UNITED STATES PATENT AND TRADEMARK OFFICE

APPLICATION NO.	FILING DATE	FIRST NAMED INVENTOR	ATTORNEY DOCKET NO.	CONFIRMATION NO.
10/668,065	09/23/2003	Patrick Evan O'Rourke		3011

This Office Action represents a Final Office Action for the application titled "SHOWER CADDY FASTENER," filed September 23, 2003.

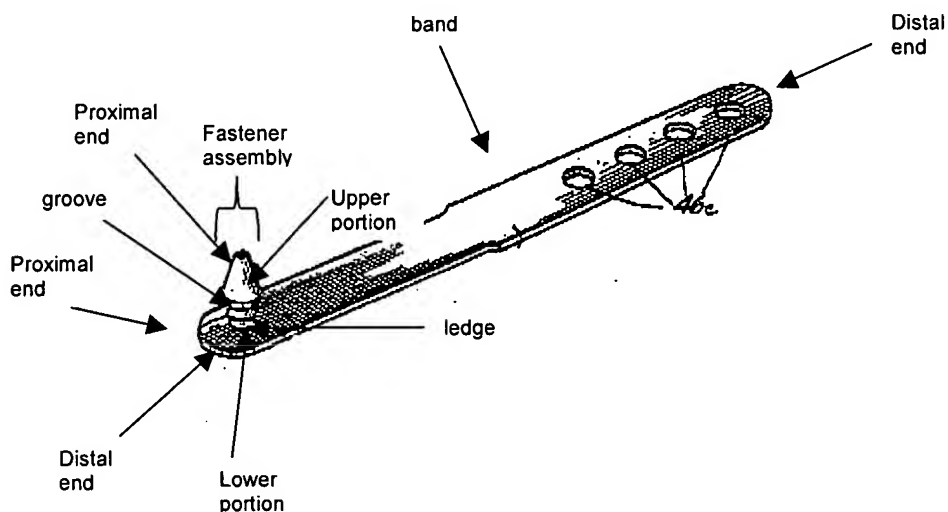
5. Claims 16-18, and 20-28 are rejected under 35 U.S.C. 102(b) as being anticipated by U.S. Patent No. 3,169,004 to Rapata.

Rapata discloses a device comprising, in combination: a band (above) extending along an axis, said band having a proximal end (above), distal end (above), upper surface and lower surface, a fastener assembly (above) having an upper portion (above) and lower portion (above), said lower portion of said fastener assembly attached to said proximal end of said band, said upper portion of said fastener assembly having a groove (above) extending along said axis, wherein said band is capable of wrapping around a shaft having said distal end of said band removeably engaging said fastener assembly, wherein said groove snap engages an arch (groove snap engages with an arch of aperture 46c), wherein said fastener assembly is further defined as having a proximal end (above) and distal end (above), wherein said fastener assembly is further defined as comprising a ledge (above) attached to said distal end of said fastener assembly, wherein said distal end of said band is further defined as comprising an aperture (46c) having a proximal and distal edge, wherein said ledge is positioned above the upper surface of said band at a distance which permits said distal edge of said aperture in said distal end of said band, to fit between said ledge and said upper surface of said band, wherein said aperture in said distal end of said band fits over and around said fastener assembly, wherein said distal end of said band is further secured in place to said fastener assembly by said ledge, wherein said band is further defined as being formed from a no-slip material that is flexible and elastic (column 2, lines 25-28), wherein said elastic properties of said band permit said aperture in said distal end of said band to stretch over said ledge and contract around said lower portion of said

fastener assembly, wherein said aperture in said distal end of said band is sized to fit closely and securely around said lower portion of said fastener assembly.
